Commonwealth Edison

October 18, 1984

Subject: Byron Generating Station Units 1 and 2
Braidwood Generating Station Units 1 and 2
HVAC Systems
NRC Docket Nos. 50-454/455 and 50-456/457

This letter provides additional information regarding the testing of filters and ducts in the Byron/Braidwood HVAC filter systems. This information is supplied at the request of the NRC Staff to address the questions regarding FSAR commitments.

FIGURE 5

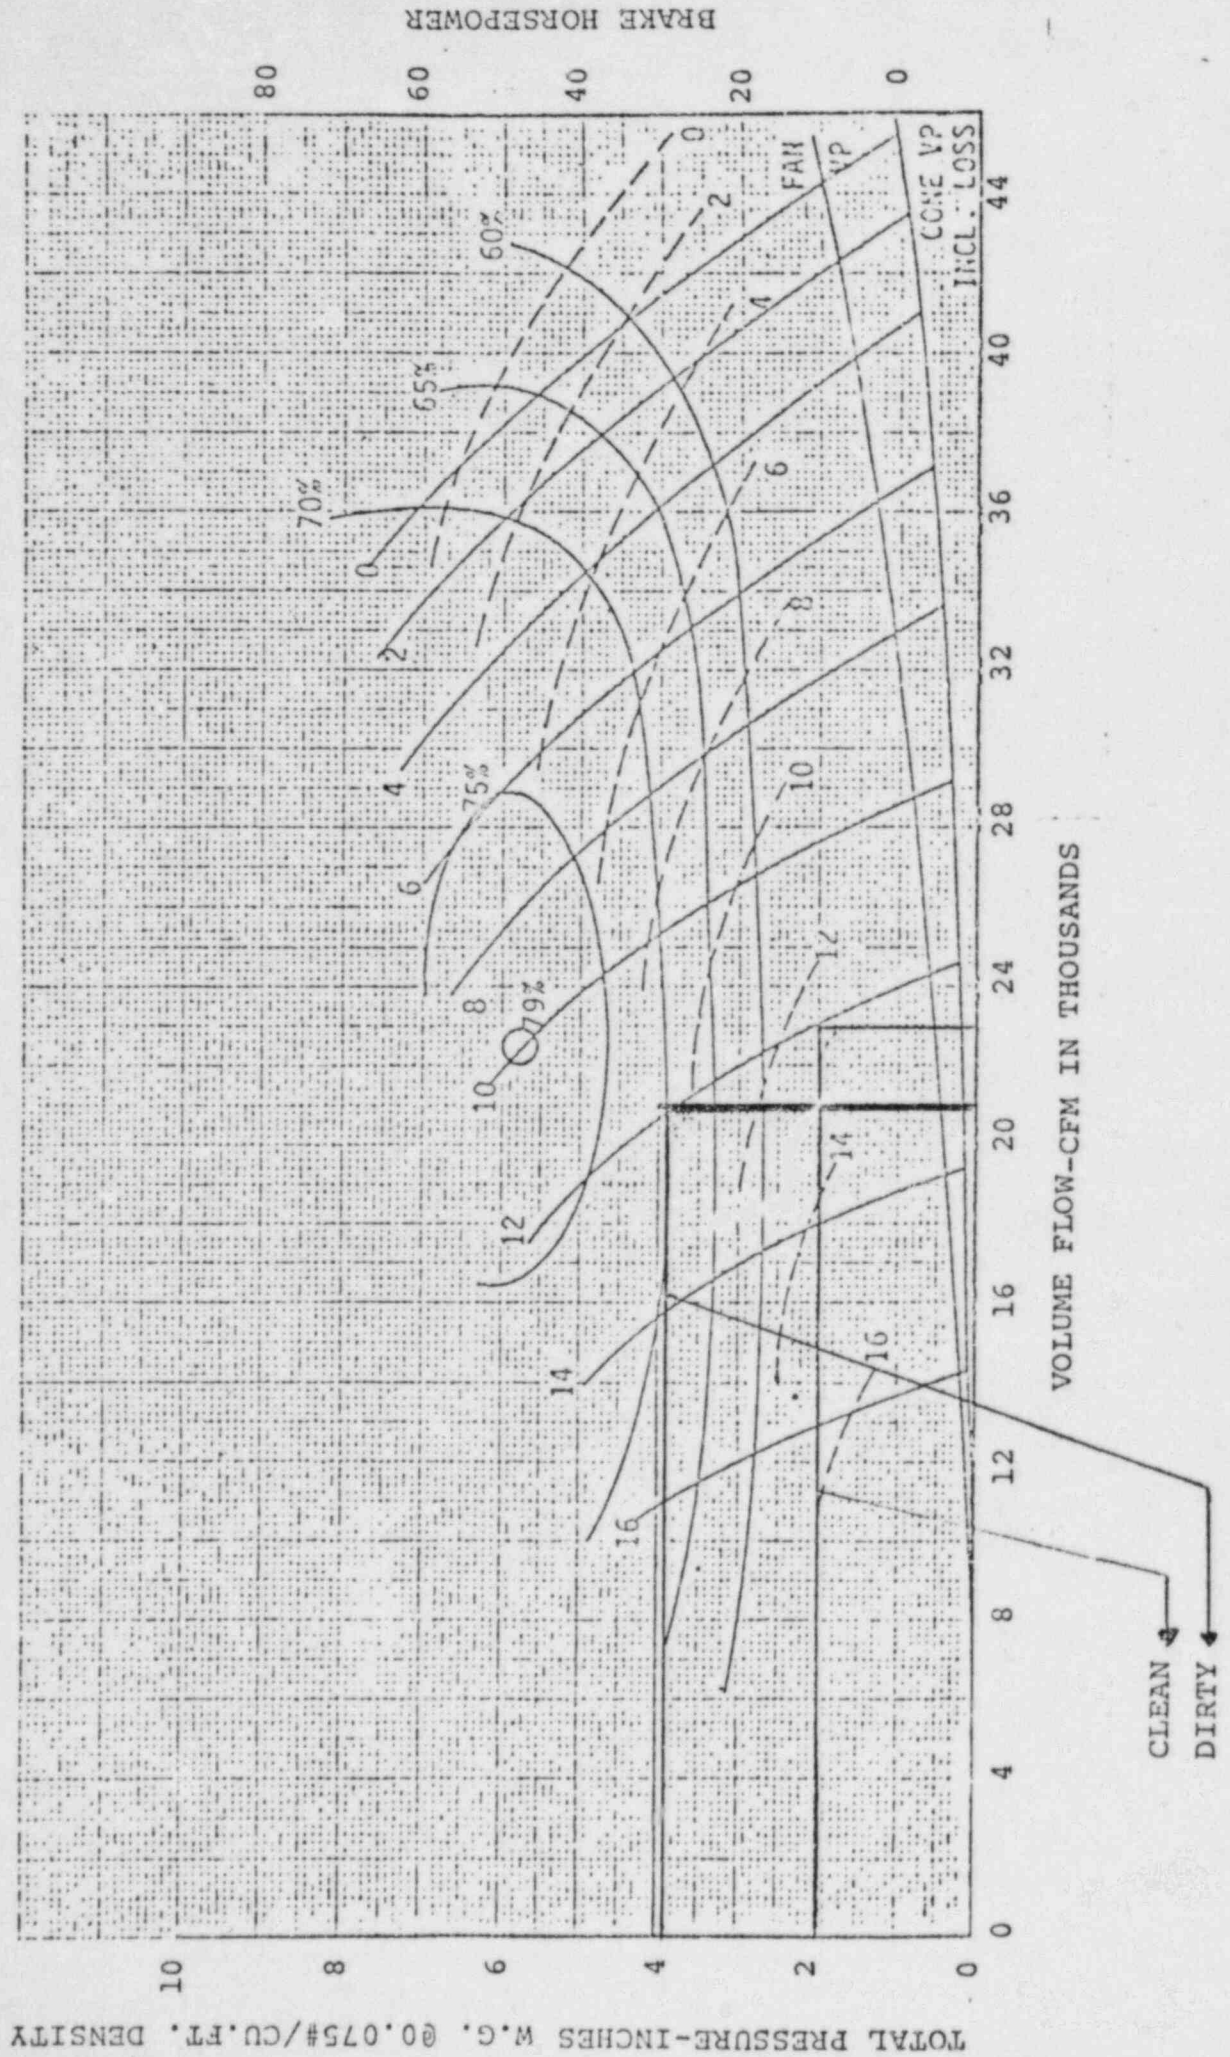
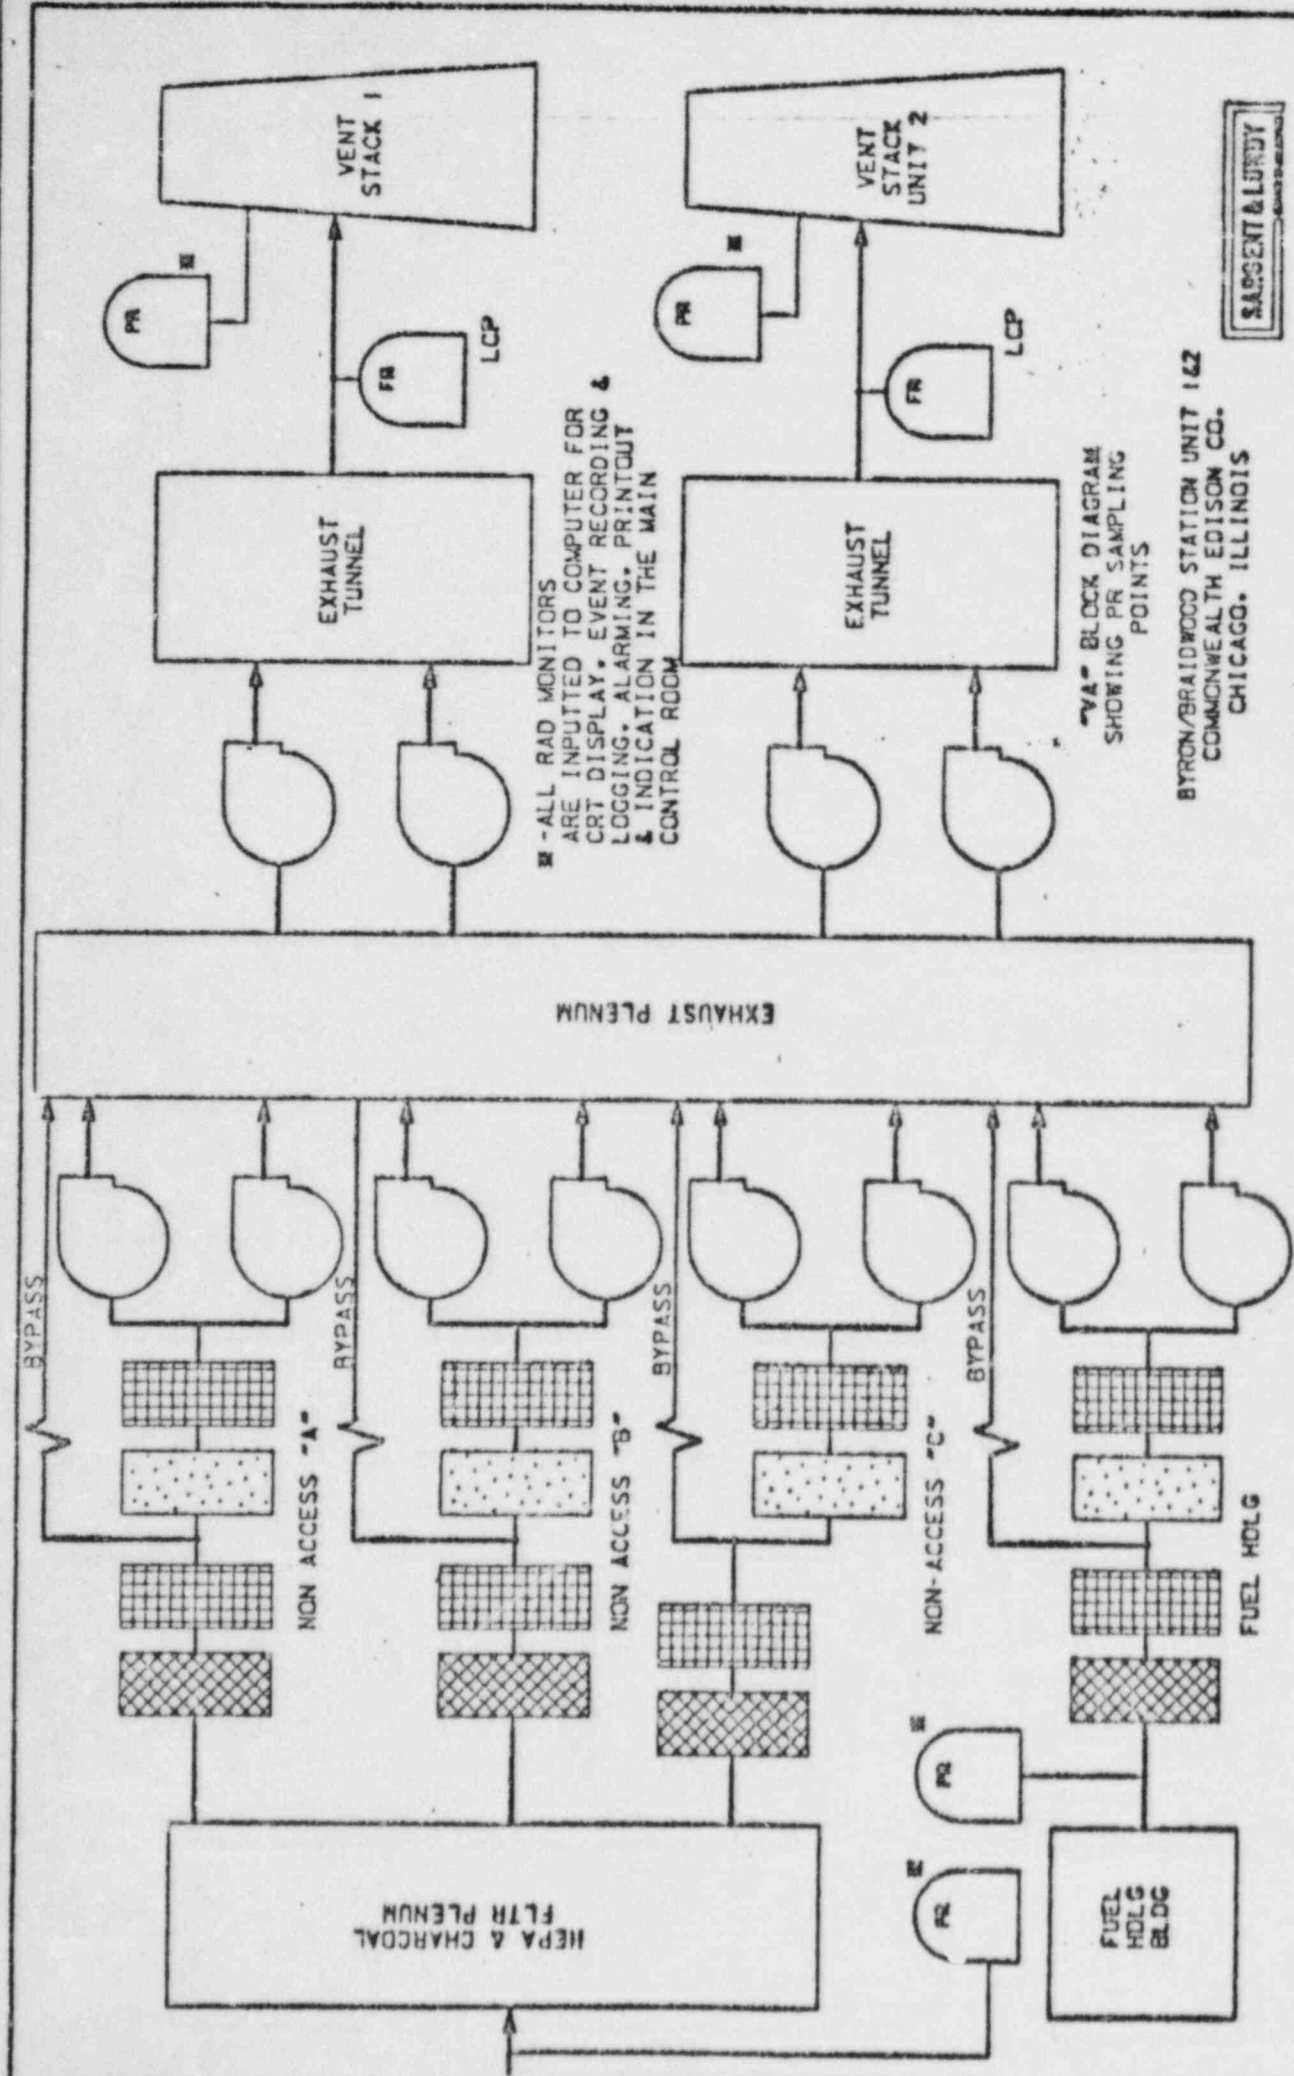
"...IT IS NOT APPARENT TO THE STAFF HOW THE APPLICANT WILL BE ABLE TO ENSURE THAT THE FLOW RATE IN THE NON-ACCESSIBLE AREA EXHAUST FILTER SYSTEMS AND THE CONTROL ROOM EMERGENCY MAKE-UP AIR FILTERS IS MAINTAINED WITHIN +10% OF ITS DESIGN FLOW WHEN FLOW IS ONLY SENSED. IT MUST BE ENSURED THAT THE RESIDENCE TIME IN THE CHARCOAL ADSORBER IS MAINTAINED AT THE DESIGN VALUE OF 0.25 SECONDS PER TWO INCHES OF CHARCOAL AND THAT THE FLOW RATE CAPABILITY OF THE HEPA FILTERS IS NOT EXCEEDED. THEREFORE, THE APPLICANT SHOULD ADDRESS HOW FLOW WILL BE MAINTAINED TO SATISFY THESE CONDITIONS..."; "...THE APPLICANT SHOULD ALSO ADDRESS THE RECORDING OF FLOW FOR THE FUEL HANDLING BUILDING FILTRATION UNITS."

FIGURES 4 AND 5 PROVIDE THE FAN NORMAL OPERATING POINTS BETWEEN THE CLEAN AND DIRTY FILTER RESISTANCE IN THE SYSTEM FOR NON-ACCESSIBLE FILTERS AND FUEL HANDLING BUILDING EXHAUST FILTERS, RESPECTIVELY. AS CAN BE SEEN FROM THESE CURVES, FOR SYSTEM NORMAL OPERATING CONDITIONS, THE FLOW VARIATION BETWEEN TWO POINTS IS LESS THAN 10%, THUS ASSURING DESIGN FLOW.

ALSO, AS SHOWN IN FIGURE 6, THE ENTIRE EXHAUST FLOW FROM THE AUXILIARY BUILDING AND OTHER AREAS ARE MONITORED BY FLOW MONITORS LOCATED IN THE PLANT VENT STACK. THE FLOW FOR EACH TUNNEL IS INDICATED AND RECORDED ON THE LOCAL CONTROL PANEL. THE FLOW MONITORS ALSO PROVIDE A SIGNAL TO THE RADIATION DETECTION CABINETS.
